PRODUCT CHANGE NOTIFICATION (PCN)

AMJE0909-0100-WHB-24
MODULAR CABLE

CHANGE NOTIFICATION: PCN 20220509_AMJE0909-0100-WHB-24

DESCRIPTION OF CHANGES:
CHANGE OF DATA SHEET
CHANGE OF DATA SHEET
New Draw.-No. ASS_7945_CArev02

AMJE0909-0100-WHB-24 OLD VERSION

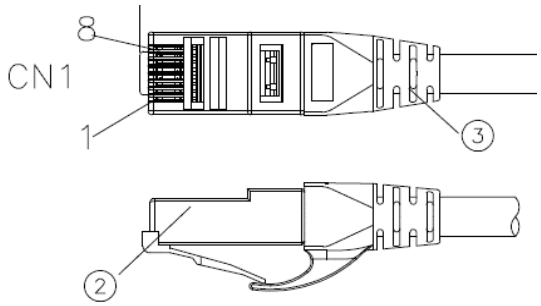
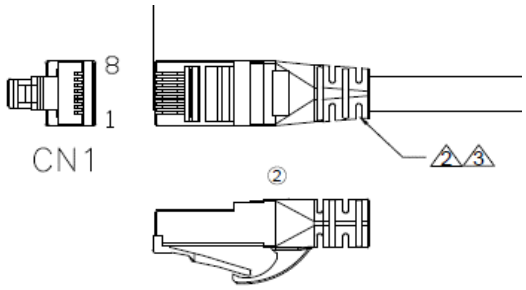
③	Molding	PVC 45P Color: see order code	NA	KG
②	CONNECTOR	RJ45 8P8C two fork Short type 3u" gold plated	2	PCS
①	CABLE	CAT6 UTP (24AWG*1PR)*4+PVC OD=5.8±0.3MM Color: see order code	NA	MM
NO:	NAME	DESCRIPTION	Q'TY	UNIT

⚠3	Molding	PVC 65P Color: see order code ②	NA	KG
⚠2	CONNECTOR	RJ45 8P8C PLUG 3u" gold plated ②	2	PCS
⚠1	CABLE	CAT6 U/UTP (24AWG*1PR)*4+Cross+PVC Jacket OD=5.8± 0.3MM Color: see order code ②	NA	MM
NO:	NAME	DESCRIPTION	Q'TY	UNIT

FOR DETAIL, PLEASE TAKE ATTACHED NEW DRAWING: FOR REFERENCE

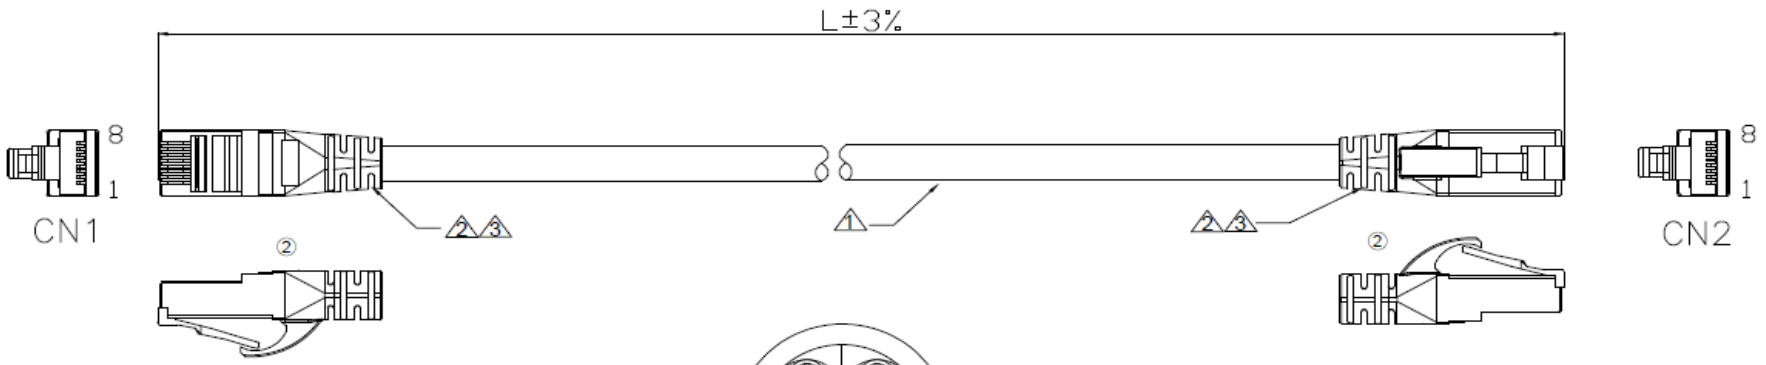
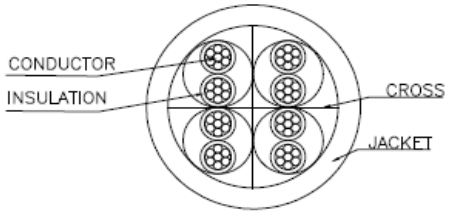
③	Molding	PVC 65P Color: see order code ②	NA	KG
②	CONNECTOR	RJ45 8P8C PLUG 3u" gold plated ②	2	PCS
①	CABLE	CAT6 U/UTP (24AWG*1PR)*4+Cross+PVC Jacket OD=5.8± 0.3MM Color: see order code ②	NA	MM
NO:	NAME	DESCRIPTION	Q'TY	UNIT

Scale	Free						Date	Name	Customer-No.
TOLERANCE						Drawn	30.03.2017	Amy	
						Approved	09.05.2022	Luca	ASSMANN WSW-No. ①AMJE0909-xxxx-xxB-24
		②	Change the plant	09.05.2022	Luca				Drawing-No. ASS 7945 CA rev02
DIM	TOL	①	Update the WSW order code	02.06.2017	Amy	ASSMANN WSW components			
		⓪	Drawn	30.03.2017	Amy				Replace / Sheet
Angle	TOL	Id.	Modification	Date	Name
